PG&E Letter DCL-02-019

Docket No. 50-275, OL-DPR-80
Docket No. 50-323, OL-DPR-82
Diablo Canyon Units 1 and 2
Response to NRC Request for Additional Information Regarding Supplement 3 to
License Amendment Request 00-06, "Alternate Repair Criteria for Axial PWSCC at
Dented Intersections in Steam Generator Tubing"

**PG&E Response to NRC Request for Additional Information Regarding
Supplement 3 to License Amendment Request 00-06, "Alternate Repair Criteria
for Axial PWSCC at Dented Intersections is Steam Generator Tubing"**

Figure 1: Representative CDF for Burst Pressure, G_m value of 0.035.

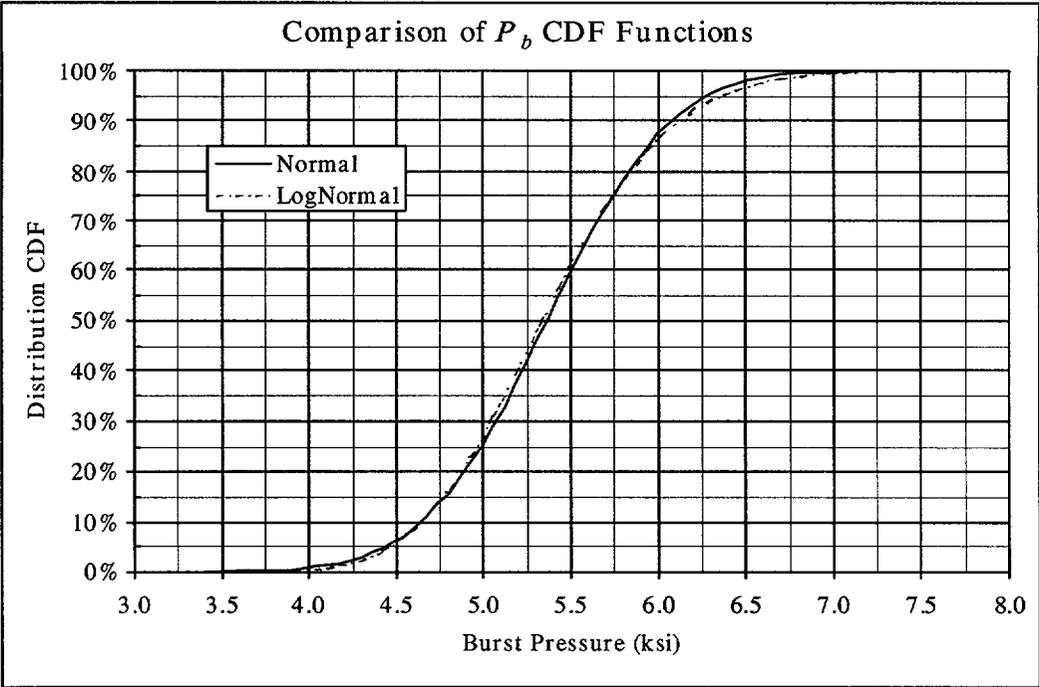
In the Monte Carlo Analysis, P_B is considered a random variable taken from a population known to be normally distributed. As a result, "t" is assumed to follow the Student's t distribution (refer to equation 5-14 in Section 5.2.4 of WCAP-15573). However, in equation 5-12, P_B is given as the product of G_B , the normalized burst pressure, and S_F , the sum of the yield and ultimate stresses. G_B is log-normally distributed and S_F is normally distributed. As a result, the distribution of the product (i.e., P_B) does not have a simple algebraic form, but can be obtained numerically by direct Monte Carlo simulation. Since the distribution of P_B is not a normal distribution, provide the basis for treating "t", as defined in equation 5-14, as a random variable that follows the Student's t distribution. If the distribution of P_B is approximated with a bounding normal distribution, provide the justification and an assessment of the impact.

Section 5.2.4 of WCAP-15573, Revision 1, was written to discuss estimating the probability of burst for CM using deterministic analysis. It is noted in the discussion that the computations are being made for comparative purposes. The results of the analysis are illustrated on Figure 5-7 of WCAP-15573, Revision 1. The report also notes that for practical purposes the relation between the predicted and calculated values may be described as either linear-linear or log-log without much difference in the results, and that the linear-linear relationship was used for the development of the probability of burst estimates. A comparison of the cumulative distribution of the burst pressure for a representative value of the normalized burst pressure is illustrated in Figure 1 of this letter. It is apparent that the distributional characteristics are similar, and that the lower tail of the normal distribution is longer than that of the lognormal distribution. The difference in length between the two tails increases as the burst pressure decreases. Thus, using a normal distribution is conservative relative to using a lognormal distribution, i.e., the probability of low burst pressures will be estimated to be higher if the normal distribution is used for the calculations. In summary, comparative statistics, the value of 10^{-3} reported in Section 5.2.4 of WCAP-15573, Revision 1, for example, are estimated that are conservative relative to the problem at hand.

Figure 2. Pancake 80 mil Coil Vertical Amplitude Strip Charts for Axial and Circumferential EDM Notches.

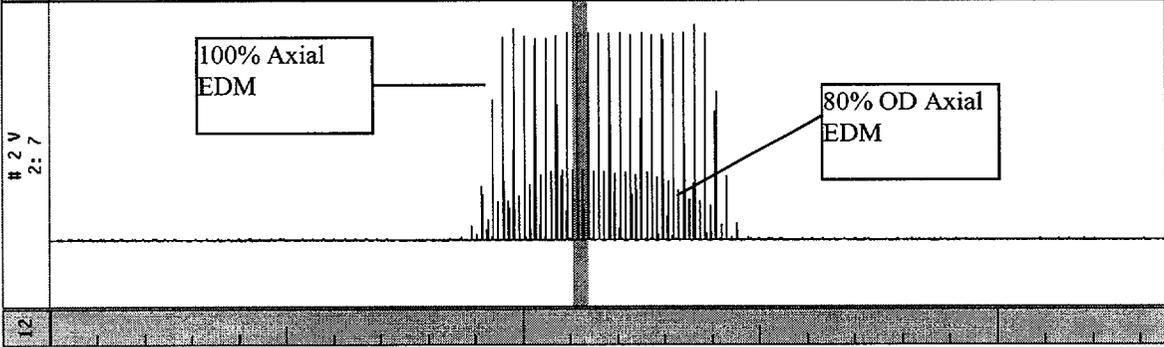
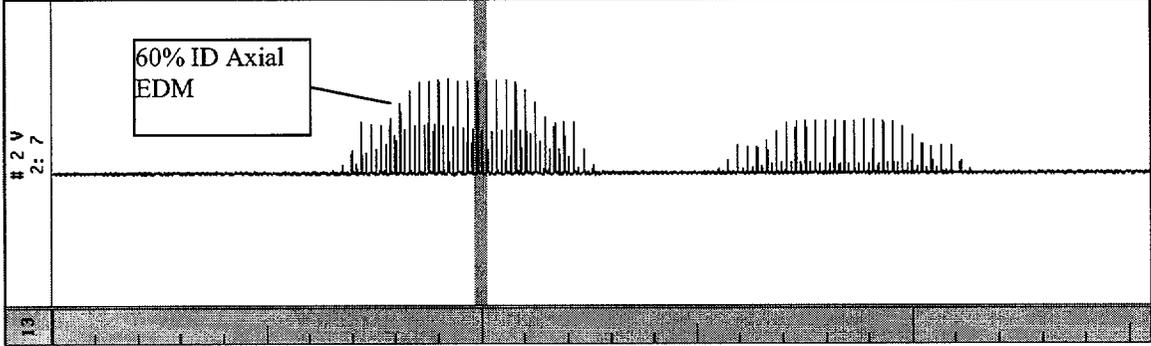
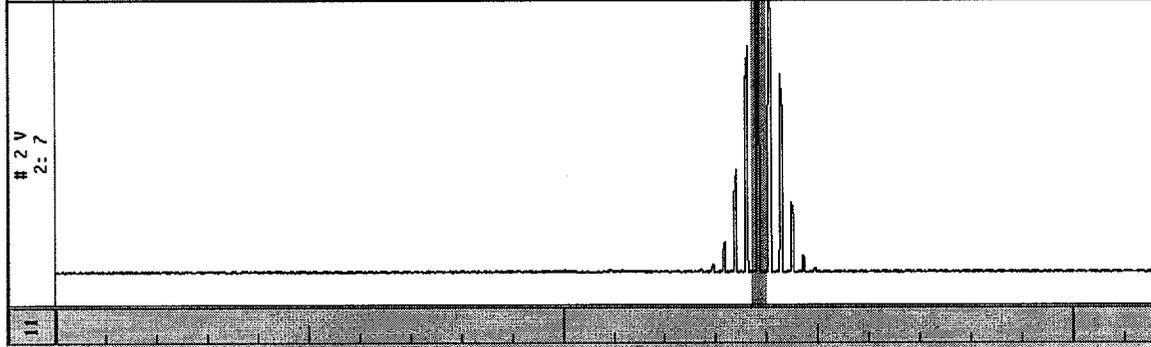
Figure 4-28 in which vertical amplitude response from an axial through wall and an 80% OD EDM notch are compared shows the data at a frequency of 300 kHz. However, the proposed NDE method for determination of the separation distance between mixed mode cracks is based on analyzing the data at a frequency of 600 kHz. Therefore, please provide either this Figure displaying the data at a frequency of 600 kHz or a brief explanation of the difference in frequency.

Figure 2 of this letter provides the data of Figure 4-28 of WCAP-15573, Revision 1, displayed at a frequency of 600 kHz.
